**TO:** Jonathan Seward – RAS NSW  
**FROM:** Graeme Steverson - WSP  
**SUBJECT:** Parramatta Light Rail Stage 2 EIS – Traffic and Transport Review  
**OUR REF:** PSxxxxxx-PAM-MEM-001 RevA  
**DATE:** 13 December 2022

WSP was commissioned by the Royal Agricultural Society of NSW (RAS) to provide a response to submissions for the Environmental Impact Assessment (EIS) for the Parramatta Light Rail Stage 2 which is proposed to serve the Sydney Showground. The responses in this memo directly relate to specific questions regarding traffic and transport issues.

## Figure 2.1 On corridor traffic performance from EIS

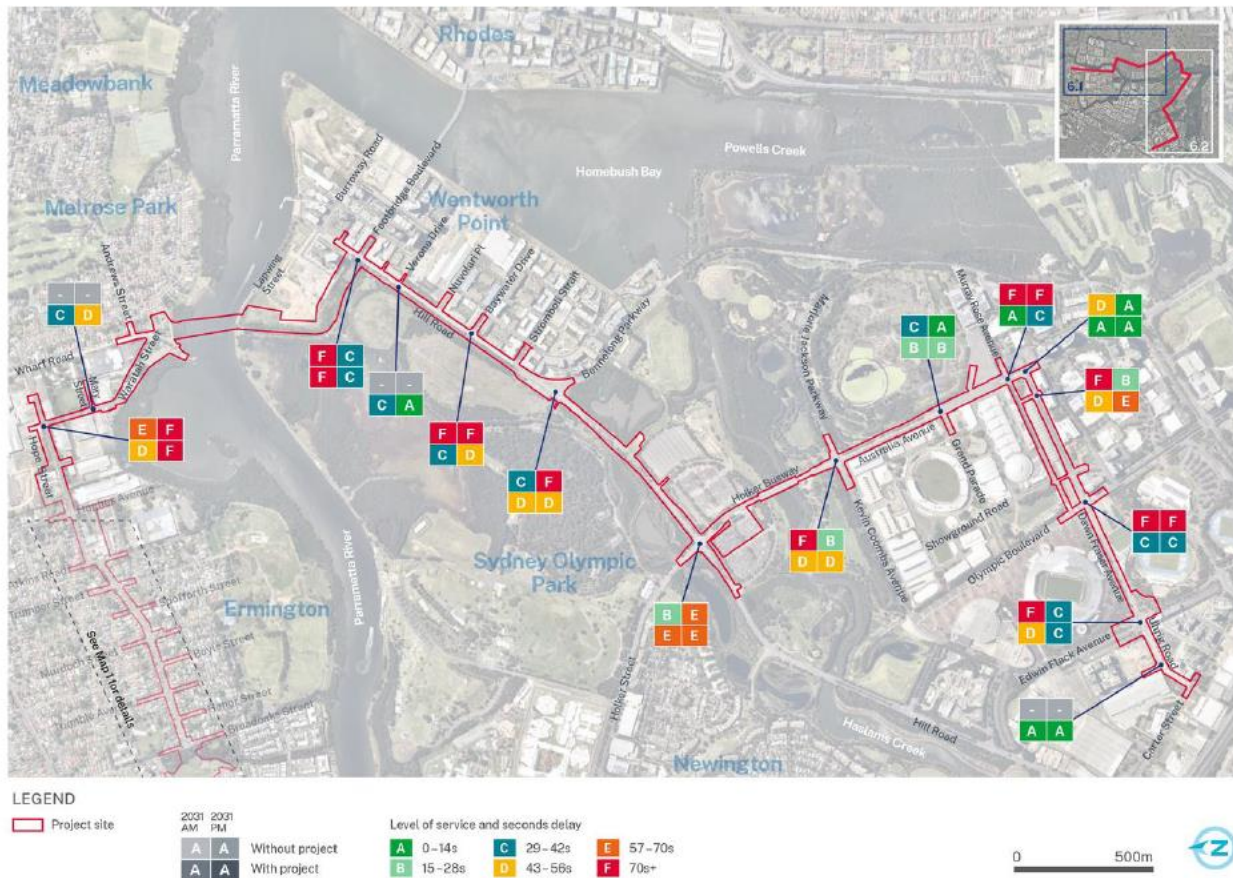
- Holker Busway / Kevin Coombs Avenue
  - It is unclear why the model assess this as operating at LoS F in the AM without project in 2031. This intersection is very lightly trafficked due to one leg being a restricted busway which only carries buses during major events. Very little traffic uses the remaining three legs of this intersection. There is no explanation for the sudden degradation in intersection performance from 2019 to 2031 without project. Adjacent increases in traffic from new development within the precinct is unlikely to use this intersection. The model appears to over reporting the poor performance of this intersection.

- Park Street / Dawn Fraser Avenue
  - It is unclear why the model assess this as operating at LoS F in the AM without project in 2031. This intersection is predominantly used by buses and taxis and local traffic on Dawn Fraser Avenue and Murray Rose Avenue. There is no explanation for the sudden degradation in intersection performance from 2019 to 2031 without project. Adjacent increases in traffic from new development within the precinct is unlikely to use this intersection. The model appears to over reporting the poor performance of this intersection.

It appears that the traffic model is over estimating the use of Dawn Fraser Avenue as a through traffic movement corridor in the “without project” scenario. There is no explanation for the significant degradation in traffic performance between 2019 and 2031 on the modelled intersections. It is also not validated against existing traffic operations which are more like LoS A or B.

## Figure 2.2 On corridor traffic performance from EIS from EIS

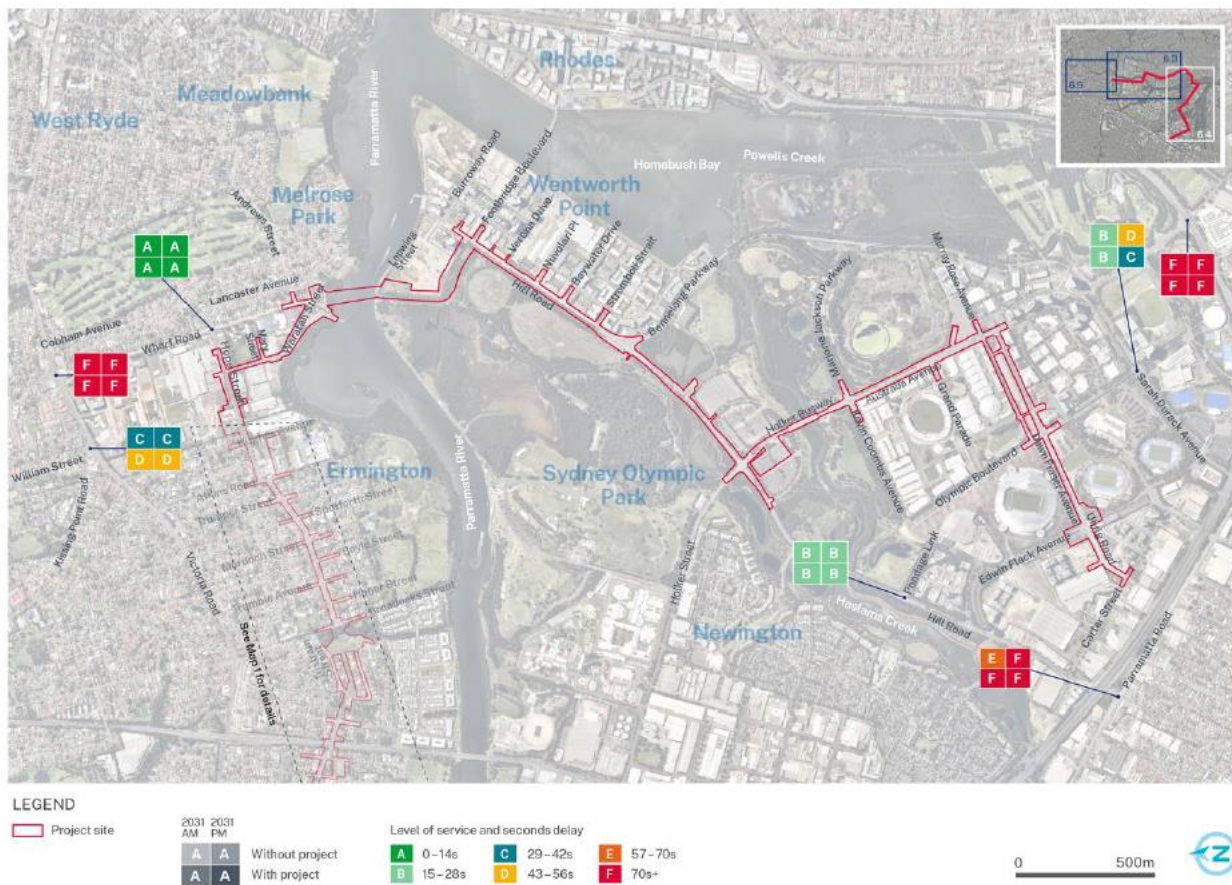
- Hill Road / Parramatta Road
  - It is unclear if the traffic model has considered the Hill Road widening project by TfNSW in this assessment.
- Australia Avenue / Dawn Fraser Avenue
  - It is unclear if the traffic model has considered the Homebush Bay Drive upgrade project by TfNSW in this assessment. This \$80M project will increase the performance of this intersection considerably whilst potentially negatively impacting downstream intersections such as Australia Avenue / Sarah Durack Avenue through induced demands.

The off corridor assessment does not appear to consider parallel TfNSW projects such as Hill Road widening or the Homebush Bay Drive intersection upgrade project. The future performance of these TfNSW projects should be incorporated into the modelling to reflect the benefits of the upgrades and justification of significant levels of investment by NSW government.

Figure 3.1 Proposed road closure of Murray Rose Avenue from EIS

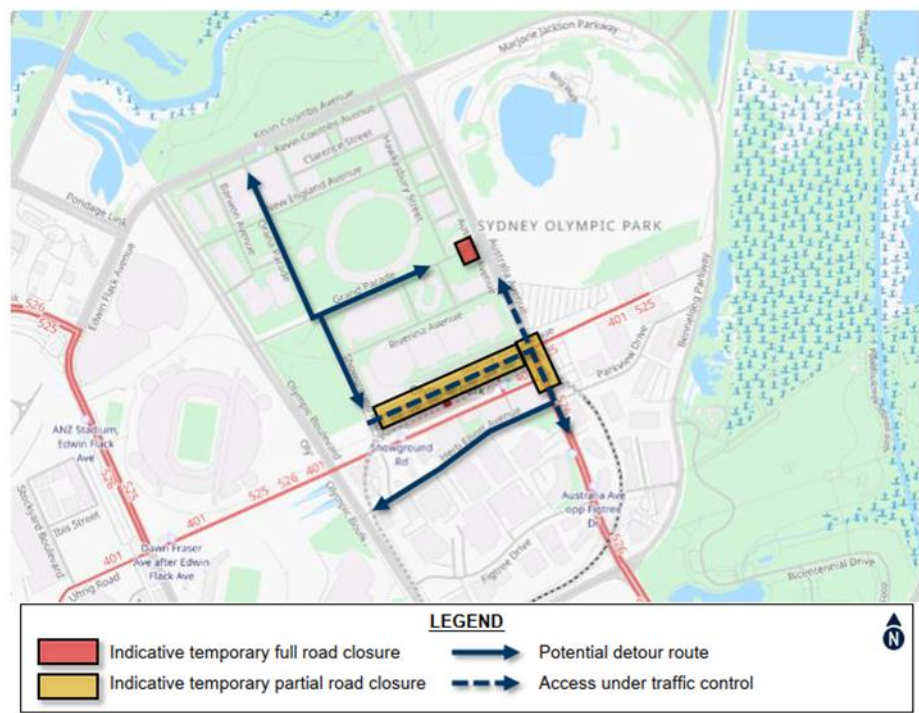
The use of roads within the Sydney Showground as potential detour routes are not considered acceptable due to the ownership, function, design and impact on event operations at Giants Stadium and the Sydney Showground.

The temporary full closure of Grand Parade at Australia Avenue will have significant impacts on staging events at all venues within the Sydney Showground over the construction period.

The propose full closure of Grand Parade and the use of Orana Parade as a detour route is highly inappropriate and demonstrates a lack of site and event familiarisation by the consultant. The impact on Grand Parade is described as “generally low”. Orana Parade is described as having sufficient capacity despite being and internal venue roadway with limited signage and line marking and raised kerbs to operate as a local road. It is unclear why Olympic Boulevard has not been suggested. Grand Parade has been described as a detour route despite it has a full closure proposed. It is also described as a detour route for Dawn Fraser Avenue.

There is no mitigation measures to deal with event operations coinciding with the construction period which is a significant omission.

Transport for NSW should work closely with RAS and SOPA to stage the closures of key parts of the local road network to ensure they do not impact the staging of major events including impacting the Aquatic Bus Terminal turning circle at the intersection of Olympic Boulevard and Herb Elliott Avenue.

Figure 3.2 Proposed road closure of Dawn Fraser Avenue and Olympic Boulevard from EIS

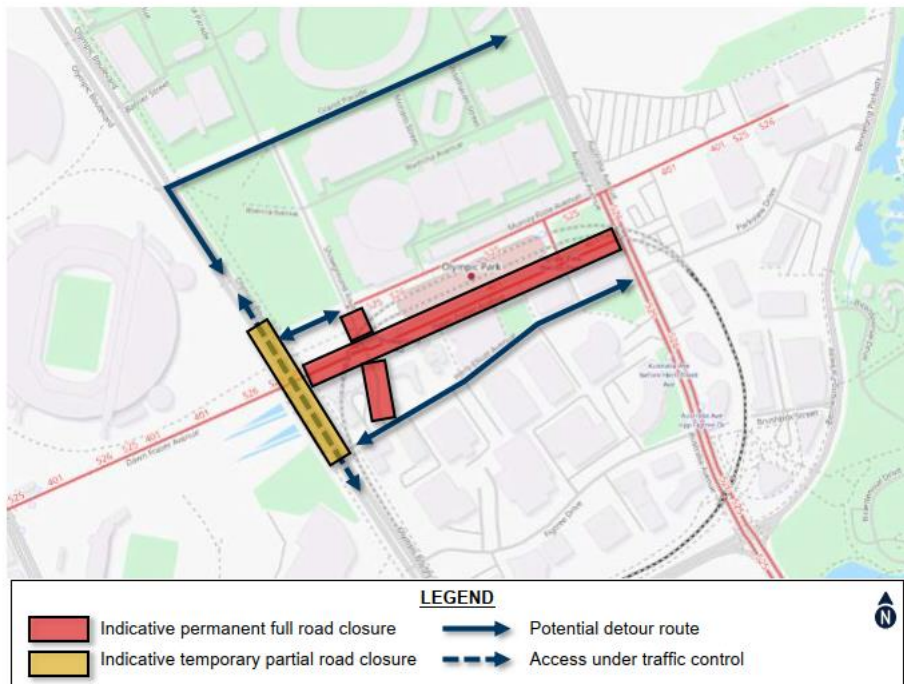
It is unclear why there is a permanent full road closure of Showground Road between Herb Elliott and Dawn Fraser Avenue. Showground Road will only be closed at Dawn Fraser Avenue.

The construction of Murray Rose Avenue West extension needs to be undertaken before the closure of Dawn Fraser Avenue between Australia Avenue and Olympic Boulevard to ensure local road and cycling access east-west is maintained throughout construction of PLR2.
